PRODUCT/PROCESS CHANGE NOTICE (PCN)

PCN #: **SG0703-02** DATE: **April 2, 2007**

PCN Type: Audio Codec Top Mark Format Change

Example: **STAC9200X5TAE B1X** The PCN details data location only. The chip outline is not to scale and device marking is not colored.

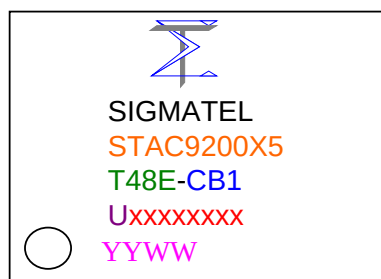
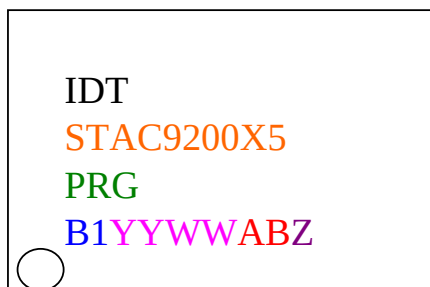
Detail of Change All 48L QFP Audio Codec devices will use the IDT standard top mark format.
There is no change to device design, process or technology.

Details: Changing from a 6 line format to a 4 line format

Line 1: Removed SigmaTel logo

Line 2: Replaced SIGMATEL name with IDT name

Line 3: Part number line, no change

Line 4: IDT package codes used instead of SigmaTel

Line 5: Lot code replaced by IDT format.

Line 6: removed date code and is added to the lot code line
